Wadsworth Parish Council's response to Calderdale Energy Park's Environmental Impact Assessment Scoping Request to the Planning Inspectorate

September 2025

Figure 7-5: UK Habitat Classification Distribution

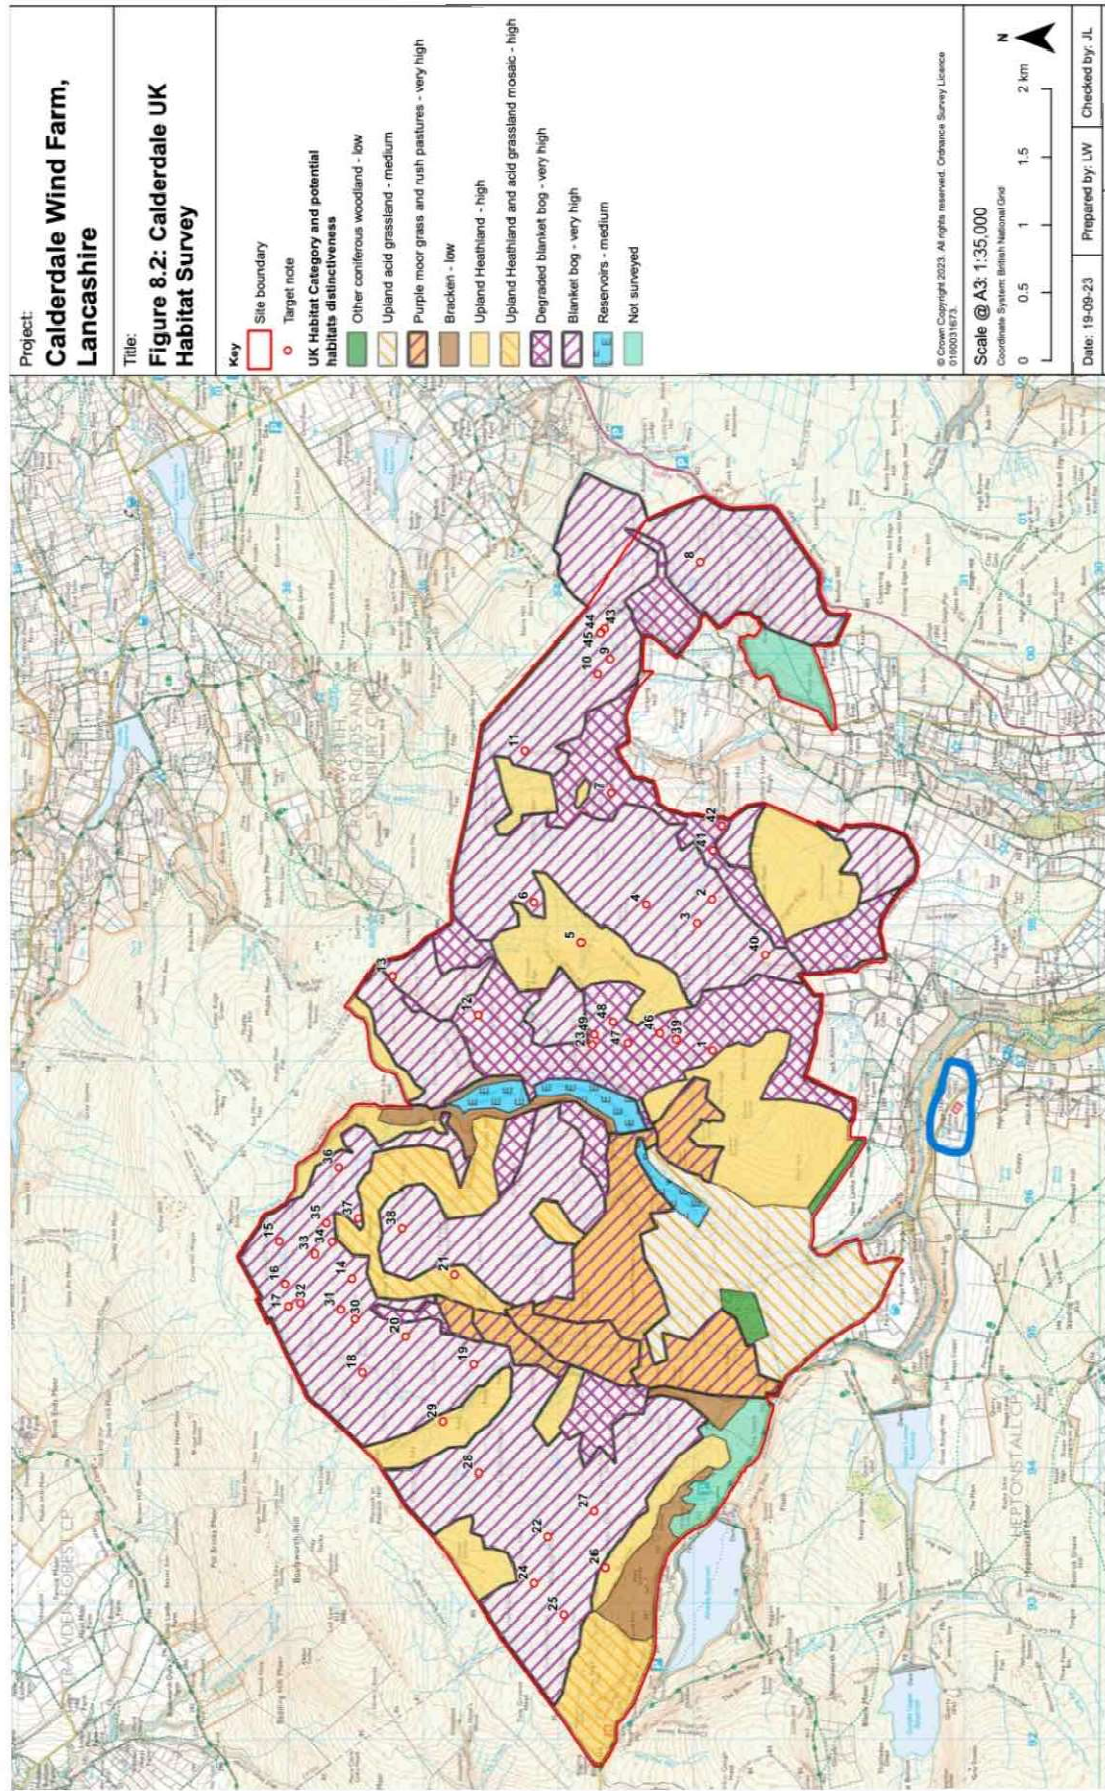
We have noticed that the Scoping Report Fig 7.5: UK Habitat map has corrected the error in the non-statutory consultation Brochure's UK Habitat map, screenshot below.

The omission of just about all of Walshaw Moor's blanket bog from its non-statutory consultation Brochure UK habitats map (except the UKHab classification of H7130 blanket bog), misleadingly made it look as if a large area of the moor could support infrastructure construction, operation and maintenance without the likelihood of significant damage to the integrity of the Habitats Regulations-protected site.

Although the error in the non-statutory consultation Brochure UK Habitats map has been corrected in the Scoping Report Fig 7-5, the misleading impression created by the non-statutory consultation Brochure map seems to have spilled into the Scoping Report's many underrepresentations of the extent of the "Turbine Area's" protected blanket bog. This misleading feature of the Scoping Report undermines its independence and objectivity.

Figure 4-2: Calderdale Cable Search Areas and Access Routes

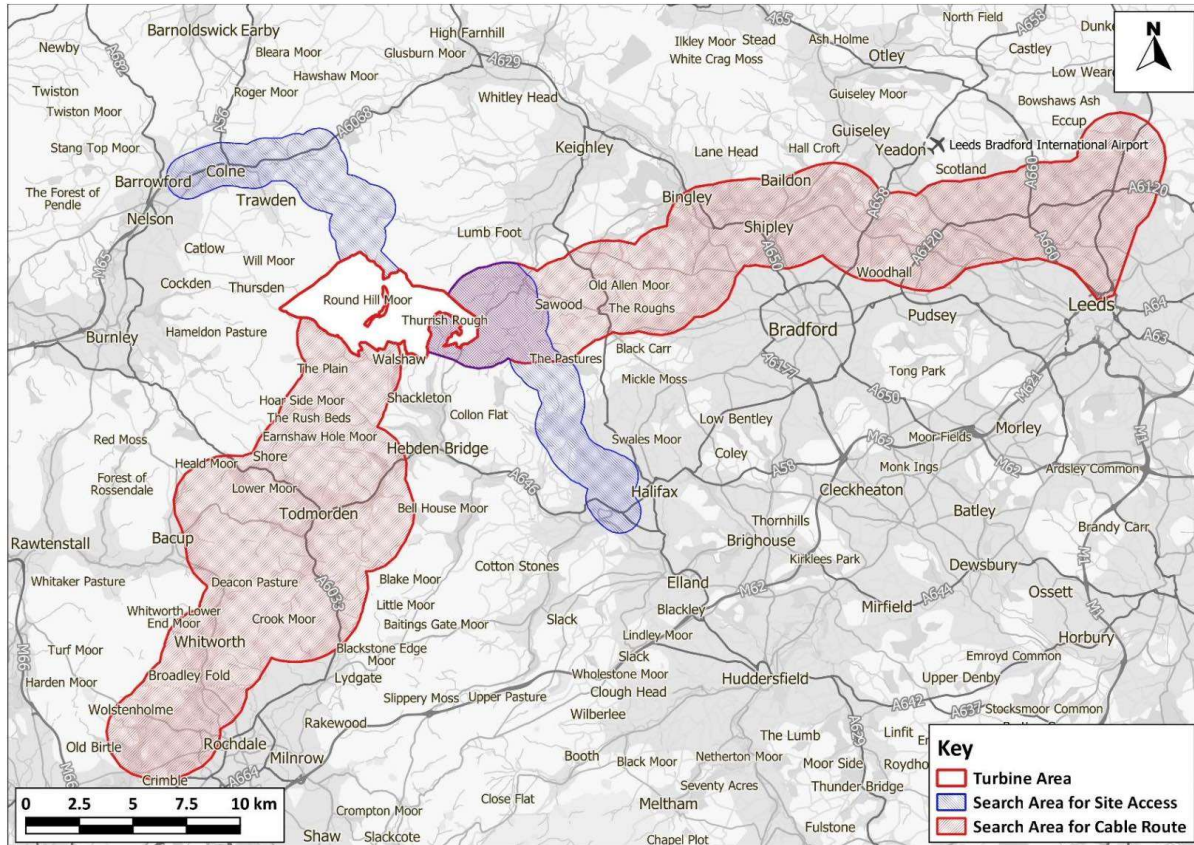
6.1 It is unclear whether the proposed environmental measures are intended to apply to offsite areas which are included in the proposed flood risk and hydrology study areas

Para 8.3.3 says the proposed study areas will be finalised once the cable corridor and site access routes are finalised and will include the buffers outlined in Fig 4.2. (Screenshot follows)
